## ADDENDUM NO. 2

Replace Roofs – Laundry & Print Shop  
Moberly Correctional Center  
Moberly, Missouri  
PROJECT NO.: C1913-02

Bid Opening Date: 1:30 PM, Thursday, June 25, 2020

LAUNDRY / PRINT SHOP  
BUILDING No. 13 -  
MEP ROOF PLAN

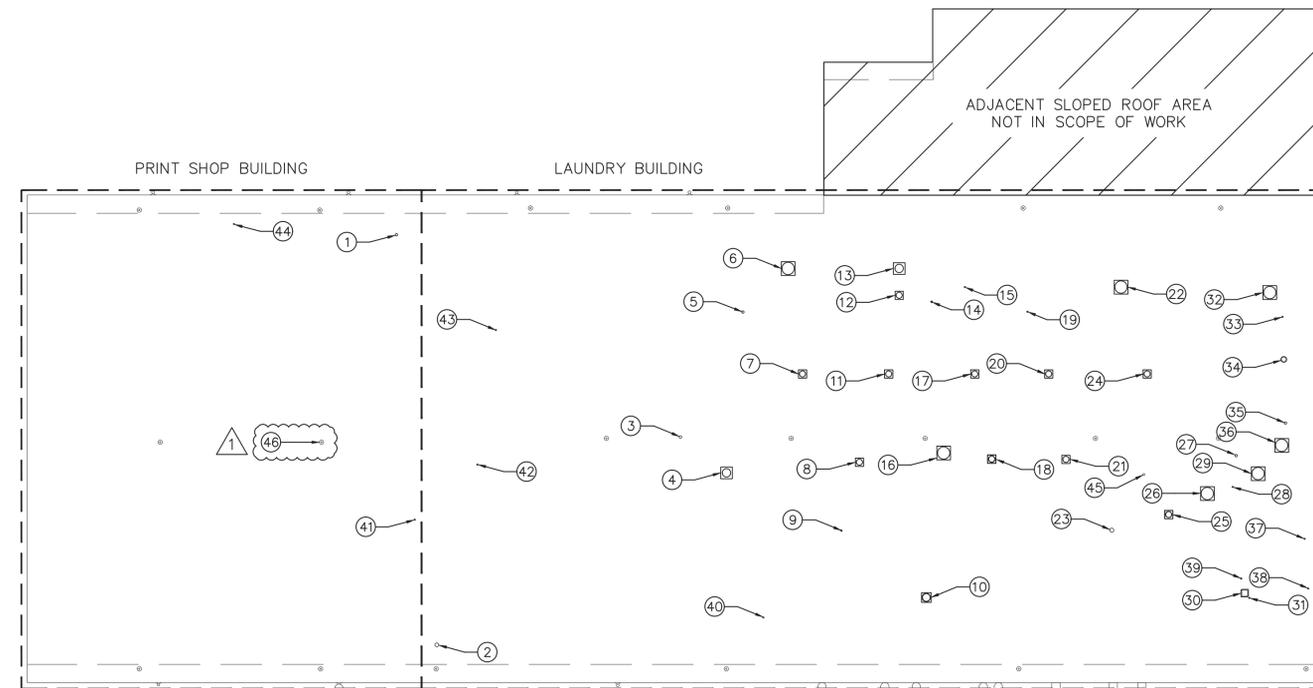
- a. REPLACE with Revised Drawing M-100 Laundry/Print Shop Building No. 13 MEP Roof Plan (attached)

④⑥ → NEW INTERIOR ROOF DRAIN AND PIPING TO MATCH ADJACENT. ⚠
